TO: DEVELOPMENT REVIEW BOARD **DATE:** 12/8/94
FROM: PROJECT COORDINATION
SUBJECT: CASE 151-DR-94

REQUEST: Approve Site Plan & Elevations for a Retail Center
PROJECT NAME: Sonora Village
LOCATION: SWC Frank Lloyd Wright & Pima Road

STAFF RECOMMENDATION: APPROVE subject to the attached stipulations.

CONCEPTUAL LANDSCAPE PLAN

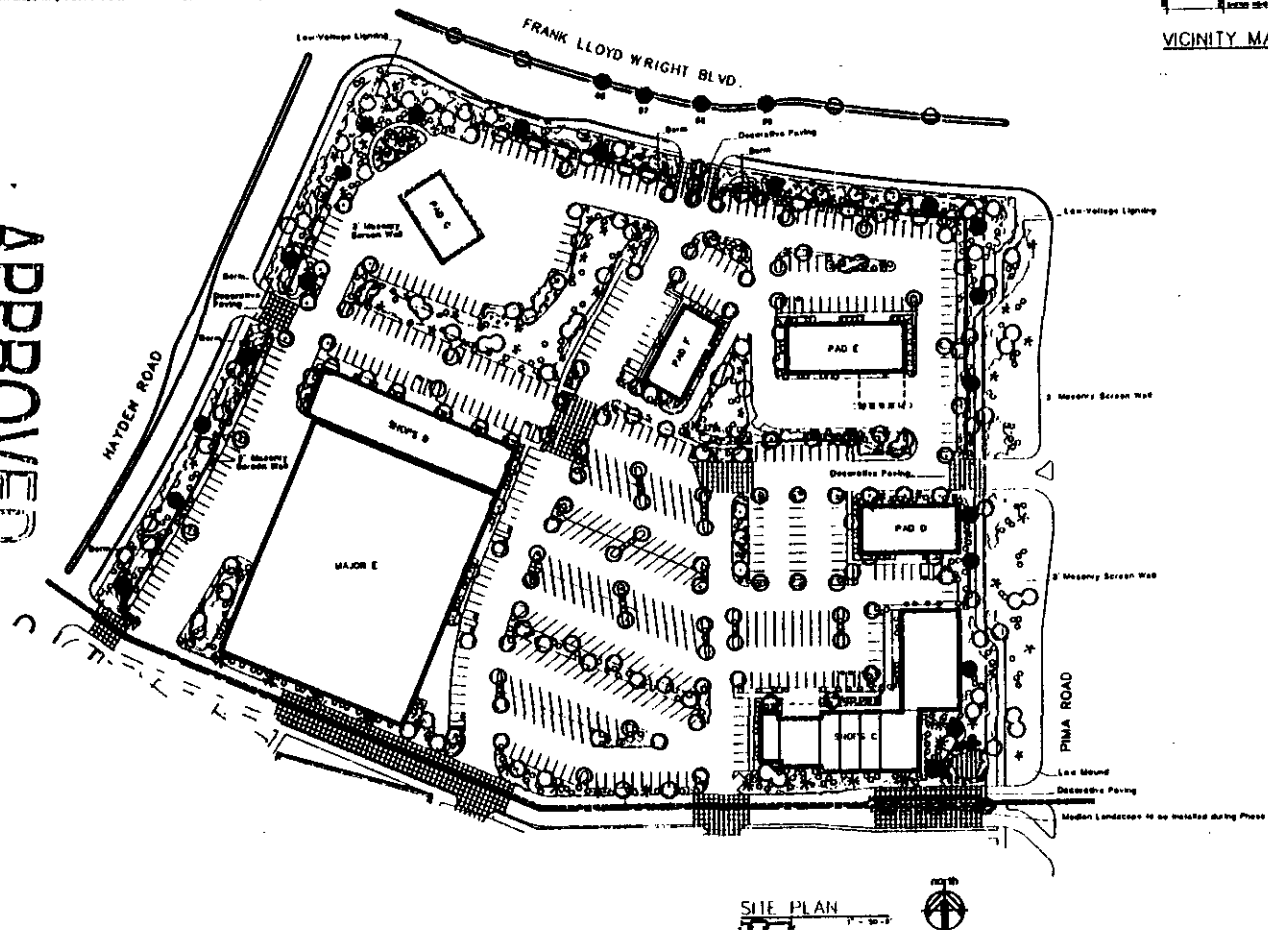
Landscape along Frank Lloyd Wright Boulevard to be installed per the Frank Lloyd Wright Boulevard Design Guidelines
